Planning Approval Consistency Assessment Form

Assessment Name:	Heritage Wall Temporary Gas Line Relocation (Barangaroo)
Prepared by:	BESIX Watpac
Prepared for:	Sydney Metro
Assessment number:	BS02
Type of assessment:	Assessment under EP&A Act 1979, Division 5.2
Version:	Final (1.0)
Planning approval No. (where relevant):	SSI 15_7400
Date required:	03 April 2023
iCentral number	SM-23-00092265

SUBJECT: Statement of Heritage Impact: Installation of temporary gas pipe, Hickson Road Retaining Wall and Cutting, Barangaroo

Figure 7: Type 1 bracket, vertical section, front view.

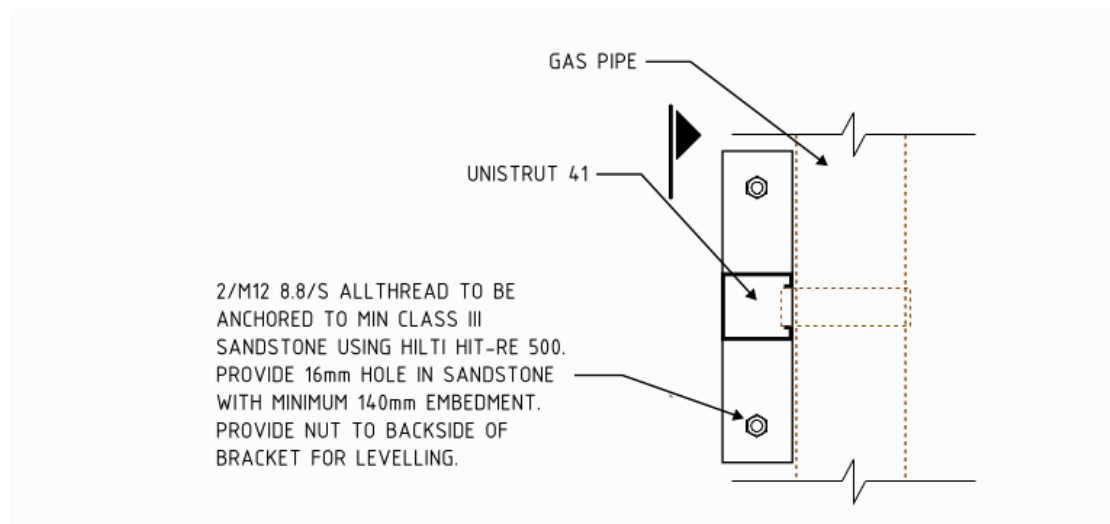
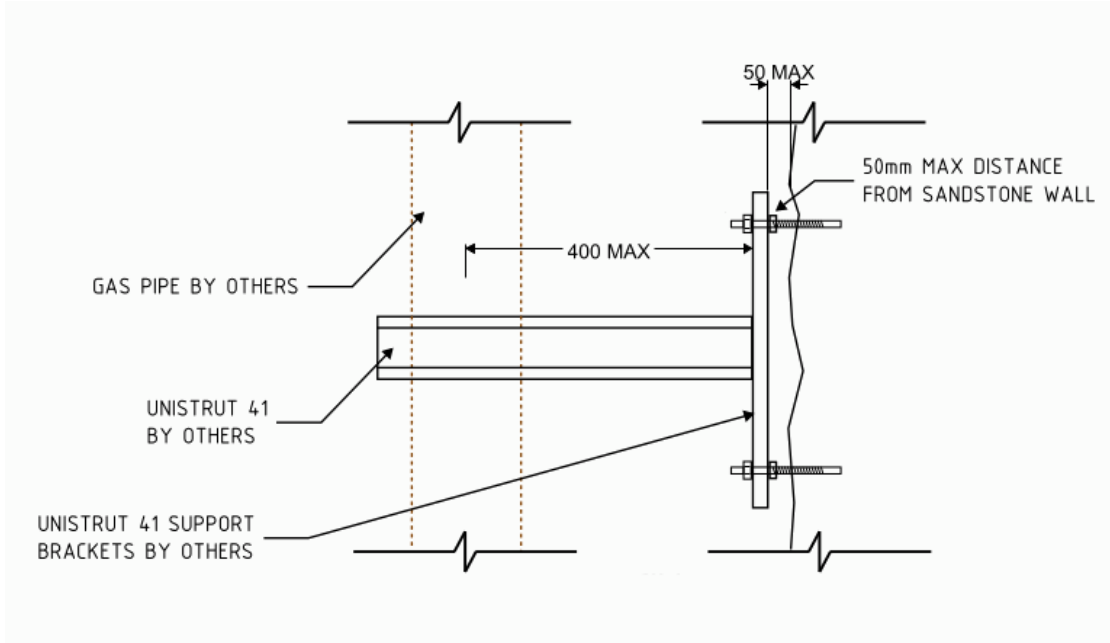
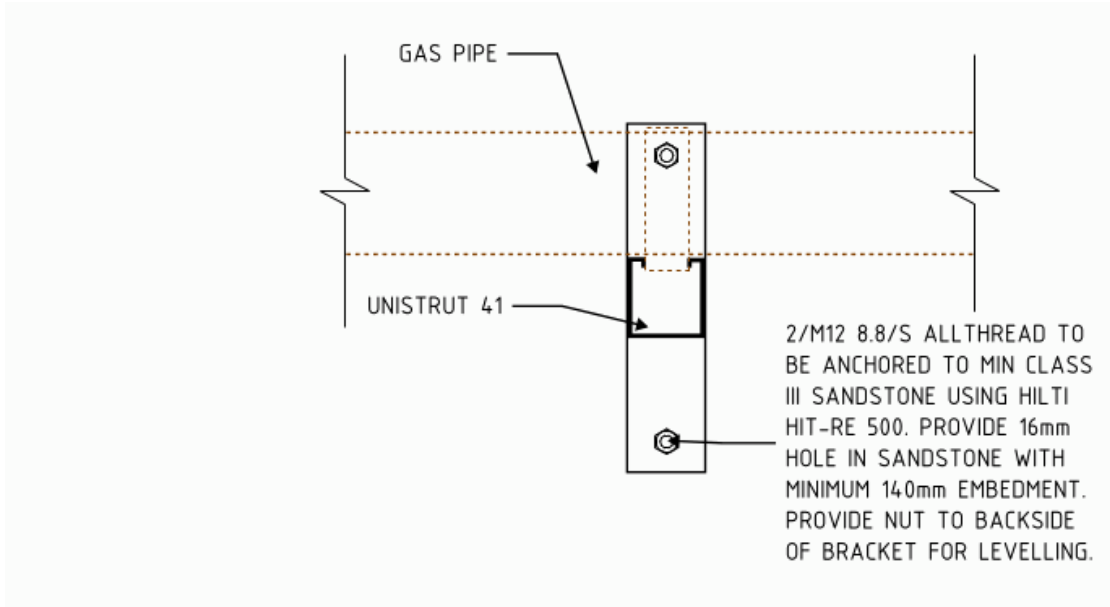
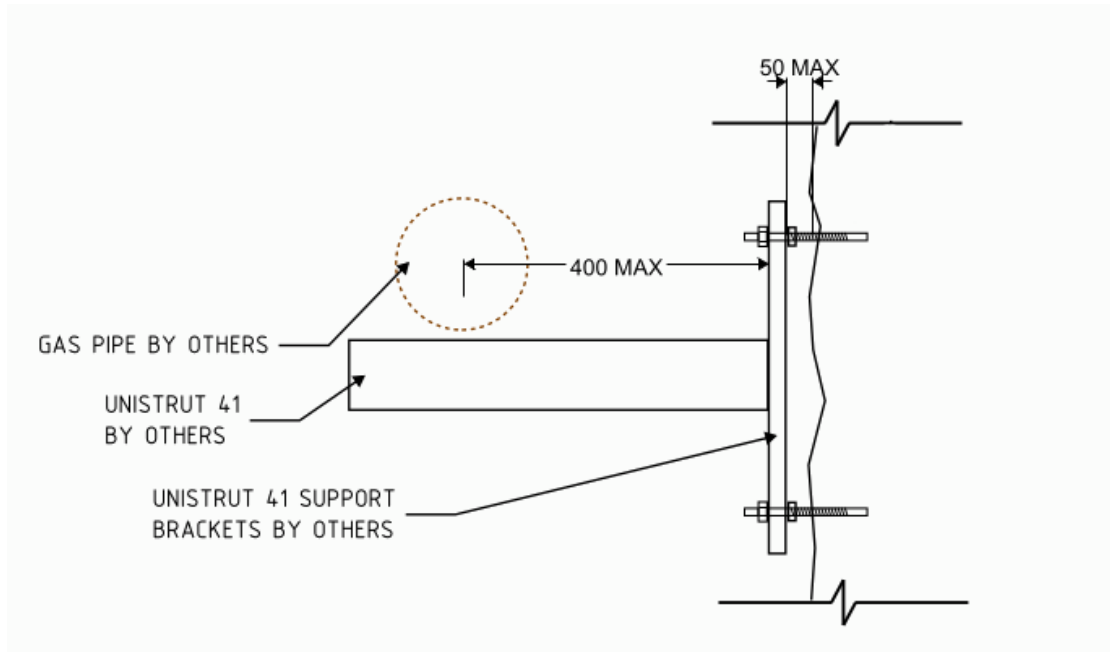
Agenda Item	Minutes
4.	<p style="text-align: center;">Discussion</p> <ul style="list-style-type: none"> Discussions about bolt selection ME enquired about the actual dimensions of core holes (16mm). MH indicated that it would be preferable to have an engineer answering questions regarding bolt selection, diameter and fixings. Further information to be provided on submission of the report to Heritage NSW for comment. TS raised an observation that he supports option 3, but would also like to indicate that the colour pallette for the make good works should match the sandstone in colour and texture JL indicated that some of the colour difference on the wall appears to be associated with aging and/or pollution Overall, the proposed is supported considering the details of dimensions and spacing are clarified.

Heritage NSW raised the questions during Heritage Working Group in relation to the diameter of the bolts and the justification for using chemical anchors over physical ones. [REDACTED] AMBS provided a preliminary response; however, please see additional information from the contractor's project engineer below for your consideration.

This response is to advise that the SOHI and additional information has adequately assessed the heritage impacts and provides rationale for the proposed methodology, consistent with minimising heritage impacts and impacts to significant fabric. The works are suitable to proceed in accordance with the SOHI.

The other was regarding justification for using chemical anchors (the epoxy) over physical ones (an expansion bolt). The discussion in the meeting was regarding the chemical anchors having been used previously and that they distribute the load more evenly across the wall rather the anchor bolts potentially increasing the stress on the existing faults and fractures. Correct. Chemical anchors induce least amount of pressure and damage on the structure and ensure that the anchors cannot be pulled off accidentally, causing damaged edges.
